**KING'S MARK  
ENVIRONMENTAL REVIEW TEAM**

**REPORT FOR  
CASTLE LANE SUBDIVISION  
ANSONIA, CONNECTICUT**

Environmental Review Team Report

Ansonia Inland Wetlands Commission

**PROPOSED  
SUBDIVISION  
NORTH SECTION**

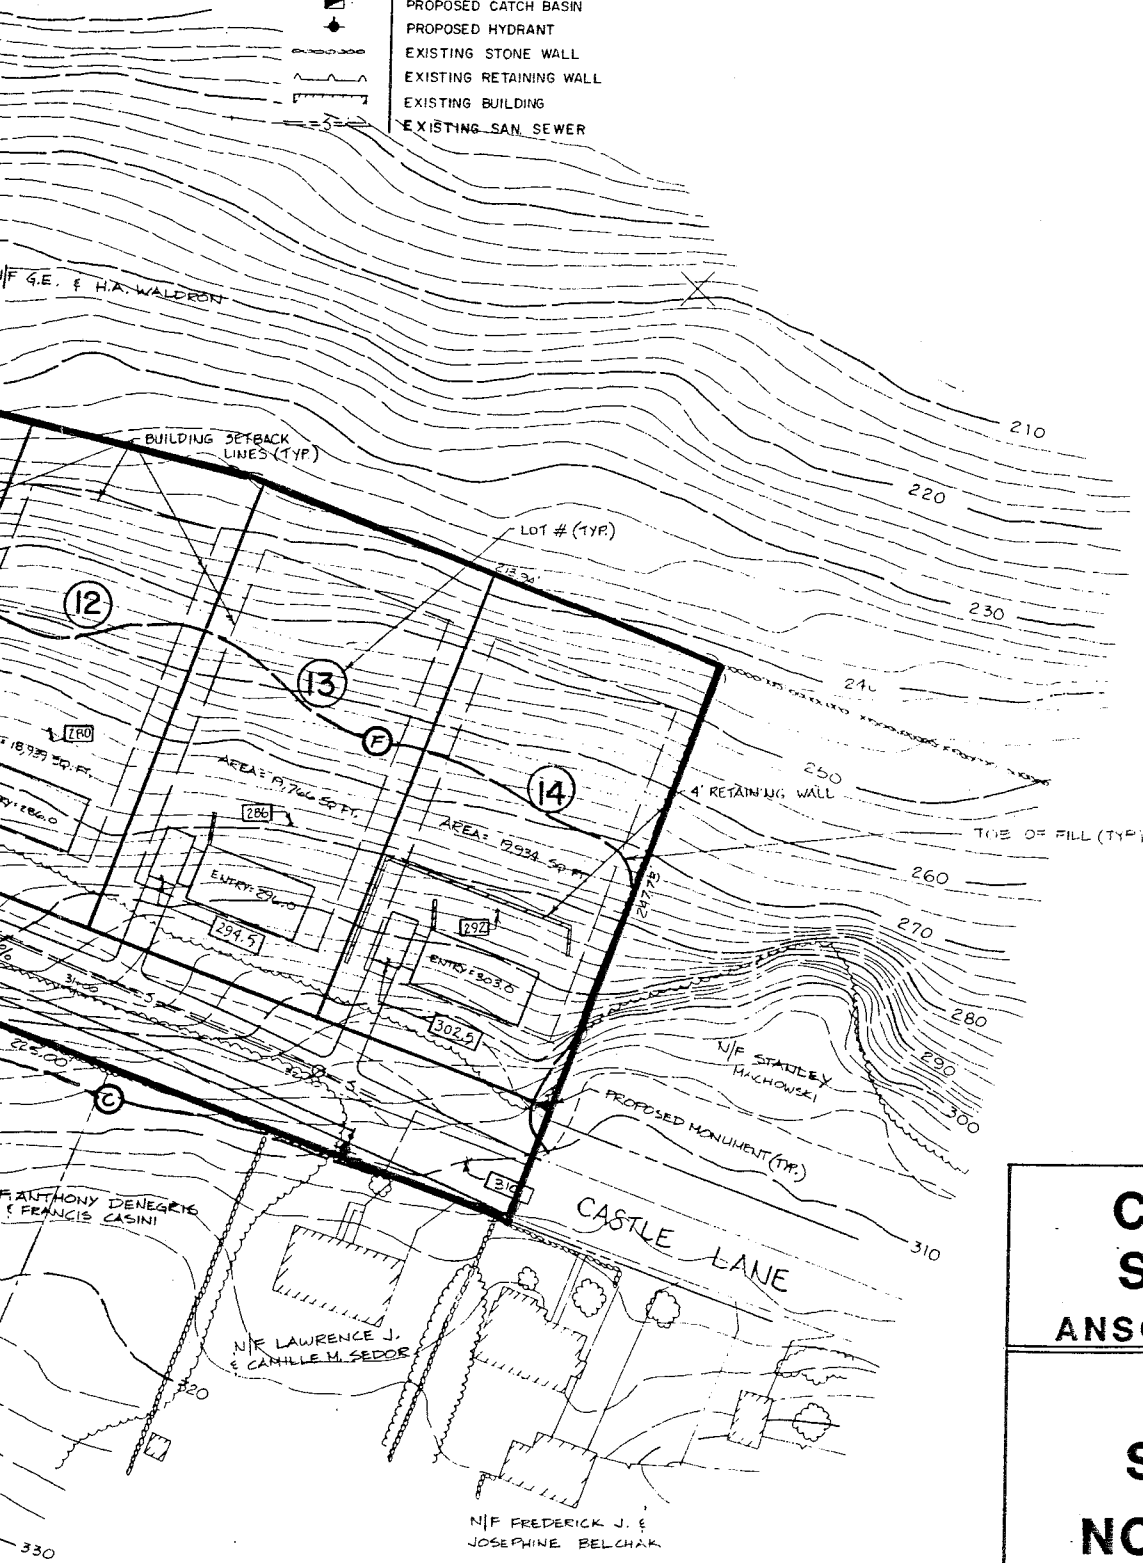
The proposed subdivision would encompass 24 house lots. Extensive cuts and fills will be needed. A single road is proposed to serve the subdivision and will connect Castle Lane with Granite Terrace. The subdivision would rely upon municipal sewers and water.

Surrounding land use is single-family residences. The proposed development is compatible with this use. Protection of the downslope area is the primary concern. The Ansonia Plan of Development recommends single-family residences in the area. The site is located in the A zone of Ansonia. Plans appear to conform to the subdivision regulations. One section may be open to interpretation. The section states that building lots "be capable of typical

building use without unusual or excessive cuts, fills, ledge removal or retaining wall construction." Proper construction and use of materials for the retaining walls should provide compliance with the section. Alternative plans could include cluster development or parks/open space. Cluster development would provide open space where none is provided. Using the land for park/open space would require that the City of Ansonia buy the property.

**WATERSHED  
HYDROLOGY**

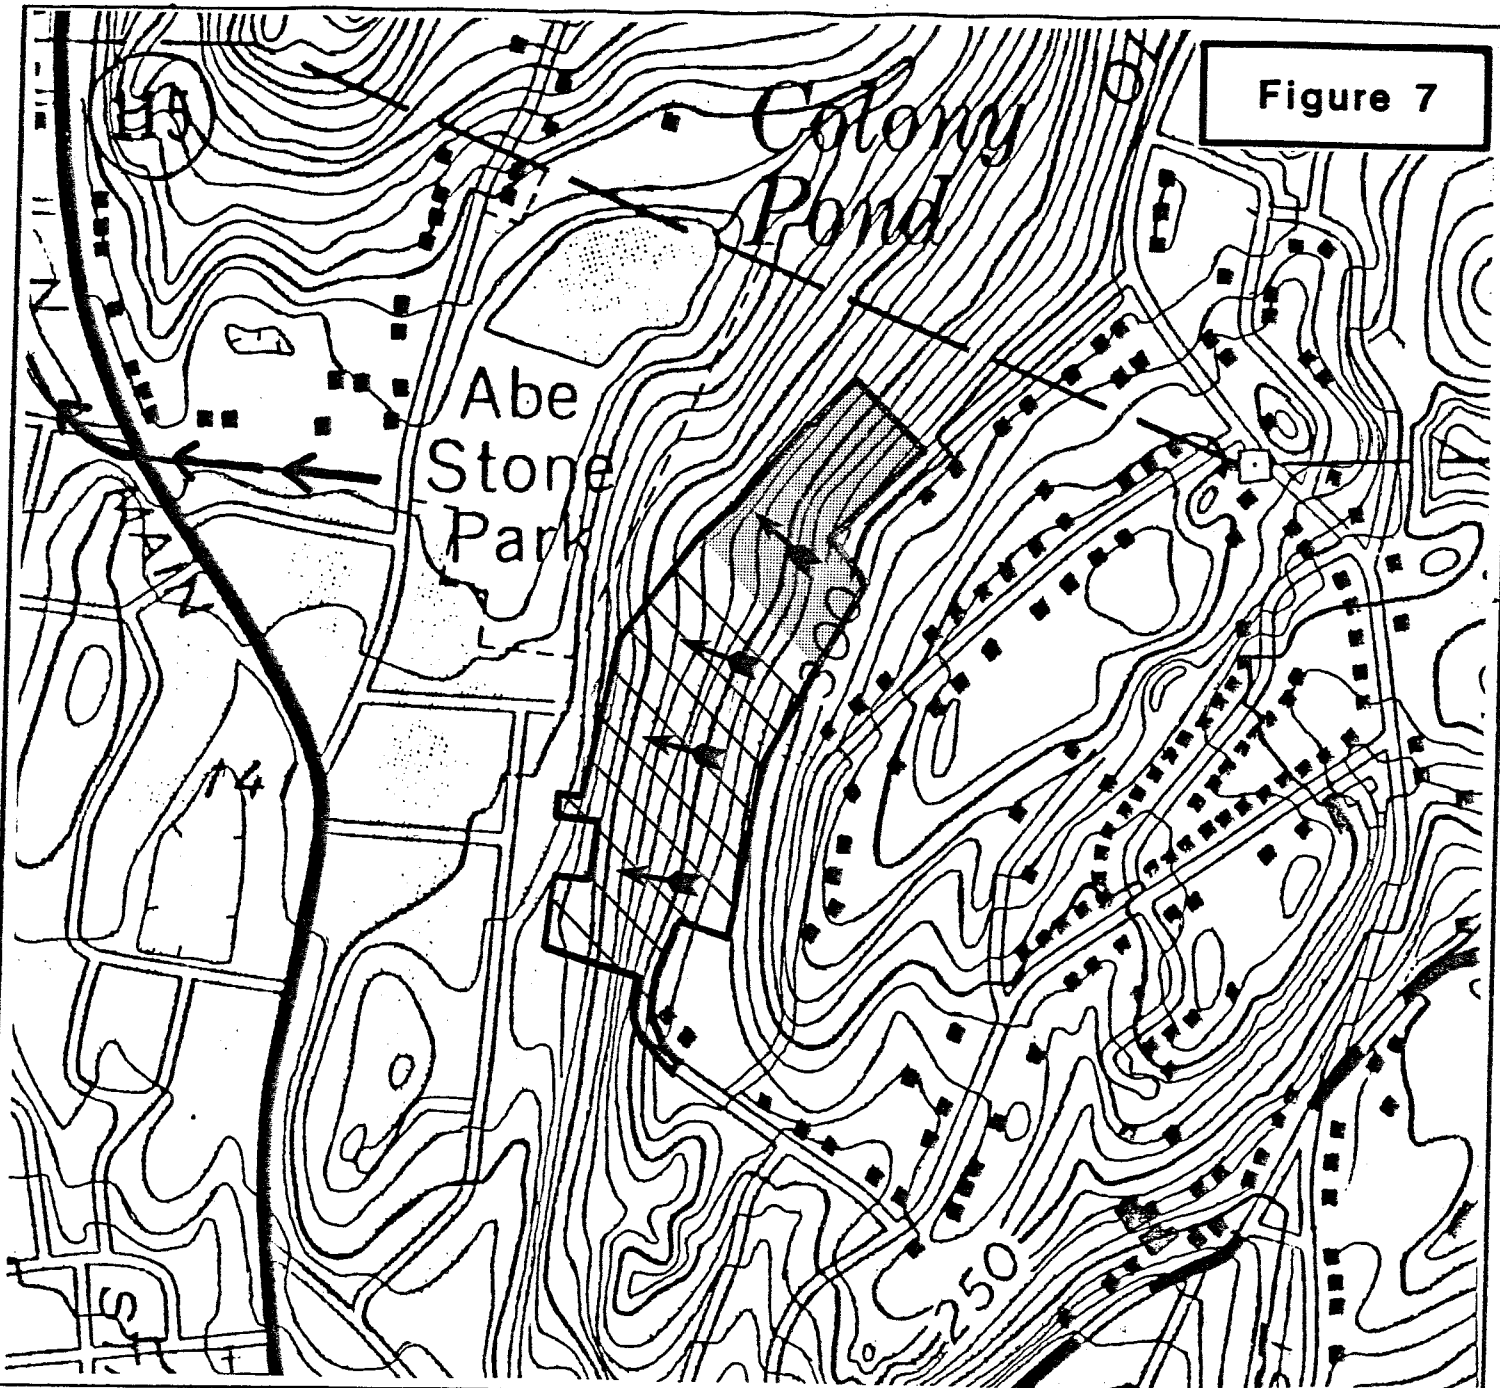
Under present conditions, the northern parts of the site drain west/northwest to Colony Pond via seasonal drainageways. The remainder of the site drains westward to the outlet stream for Colony Pond (see Figure 7). Surface runoff in the watershed which is generally east of Woodlawn Avenue and which includes the southern and central parts of the subject site, is presently intercepted by storm drainage and routed via a 12" storm drain in Gardners Lane

and Colony Street. The water is outletted to a man-made ditch, which is west of Abe Stone Park and which terminates at North Main Street. From North Main Street to the Naugatuck River, the watercourse consists of an open, natural channel paralleled by wetlands/floodplain. Based on present plans, it appears that following development, runoff from the northern parts (east of the access road) would be intercepted by road drainage and routed to the storm drains in Gardners Lane.

The two major concerns with increased runoff are the potential for flooding and streambank erosion. Team members were informed during the field review that flooding problems exist along the outlet stream for Colony Pond. The applicant's technical staff have addressed in a report made available to Team members, how they plan to handle post-development runoff increase. Because of the steep slopes that prevail throughout the site, the use of on-site detention basins does not appear to be a feasible solution for controlling post-development flows from the site. Instead, the applicant has proposed to upgrade the storm drain in Gardners Lane and Colony Street (to the beginning of the man-made ditch) from a 12" diameter pipe to an 18" to 30" pipe to handle the anticipated post-development runoff increases. The final storm drainage plan and pipe sizing needs to be carefully checked by the City engineer to ensure that existing flooding conditions are not worsened.

## SOILS

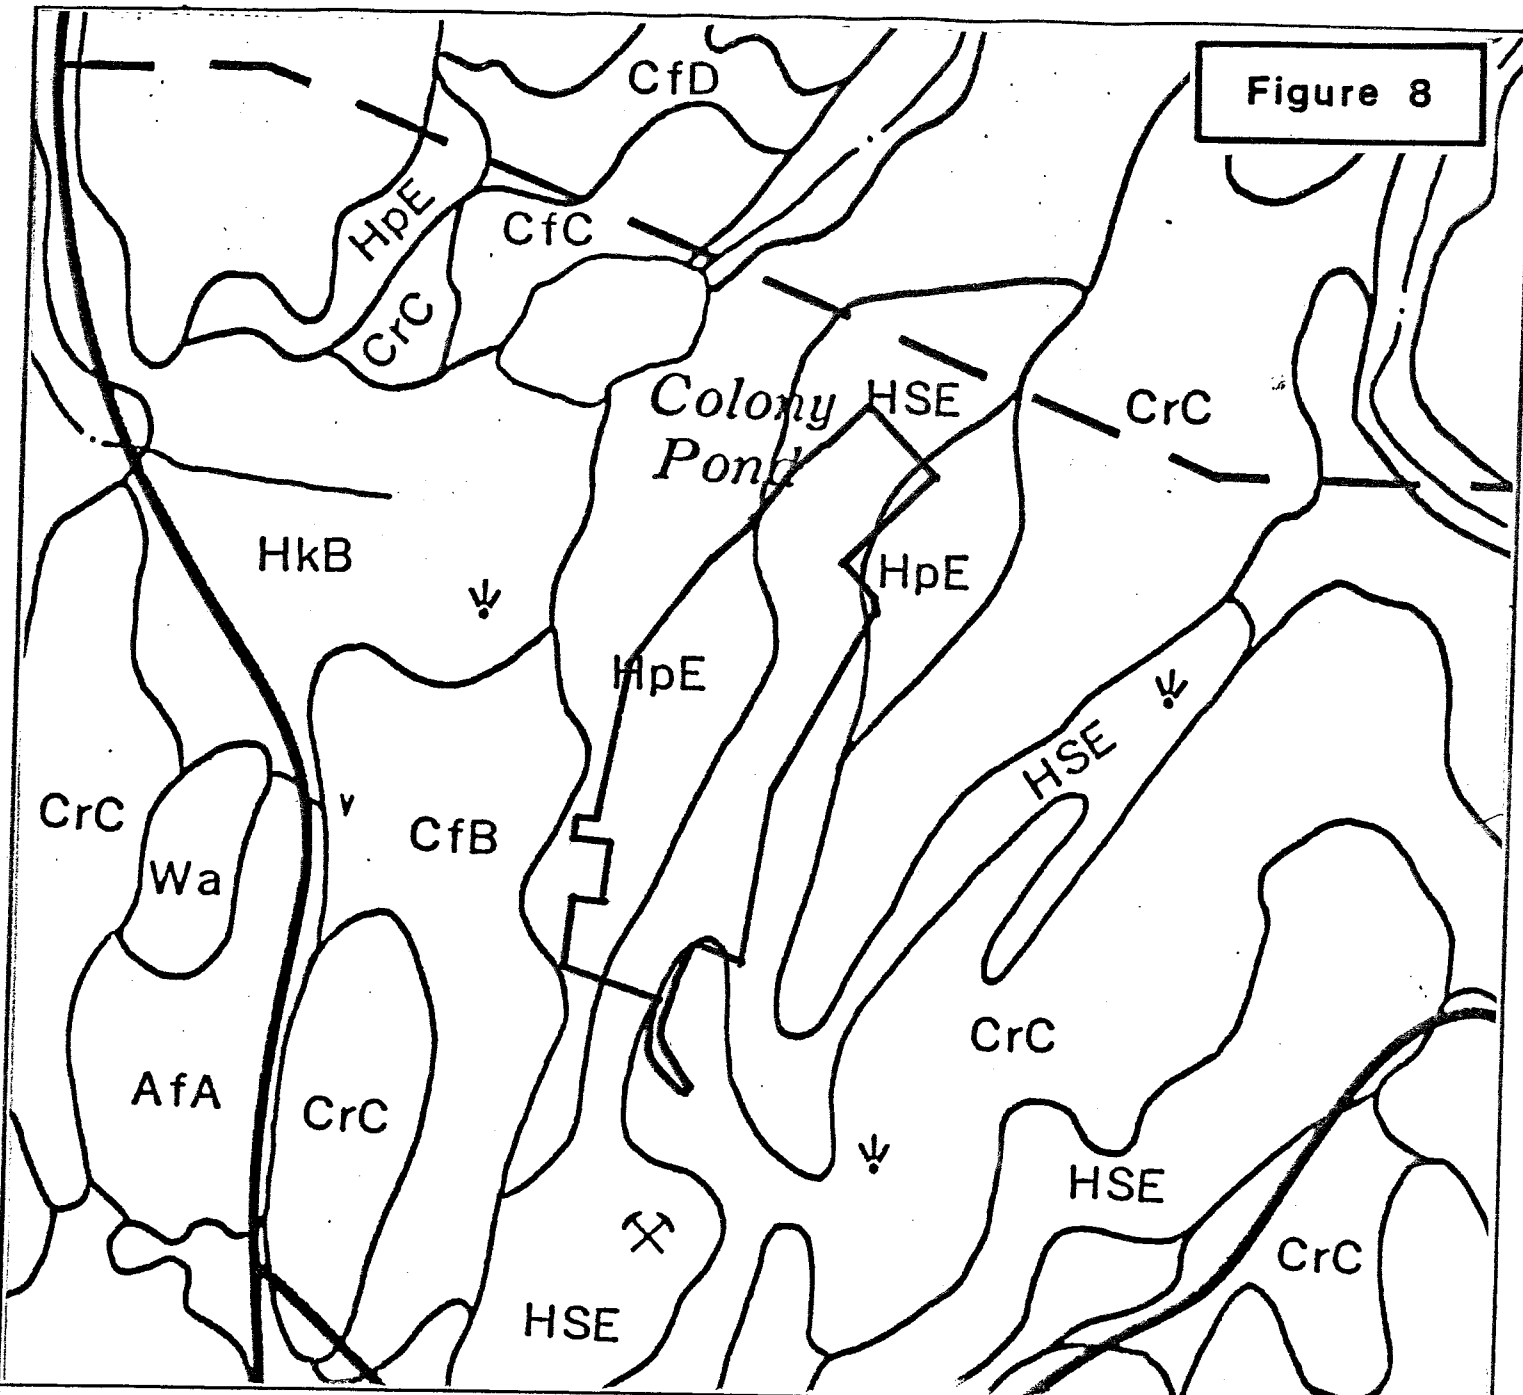
The development could be a severe erosion hazard due to the extensive clearing and grading proposed and the steep slopes with droughty, shallow to bedrock soils. It will be difficult to reestablish vegetation and topsoil will have to be brought in to provide a suitable seedbed. The large amount of rock which would be in the fill material will make proper grading difficult and the creation of concentrated flow areas with high erodibility is likely. Concentrated runoff from roofs and driveways must be safely handled to prevent erosion on the proposed fill slope. Additional rows of sediment barriers are needed considering the size of the disturbed area and slope characteristics. The planned 2:1 cut or fill slopes for most lots will not be usable yard space. These cuts will be difficult for the homeowner to maintain and are more difficult to stabilize initially. Slopes of 3:1 to 5:1 are more desirable.
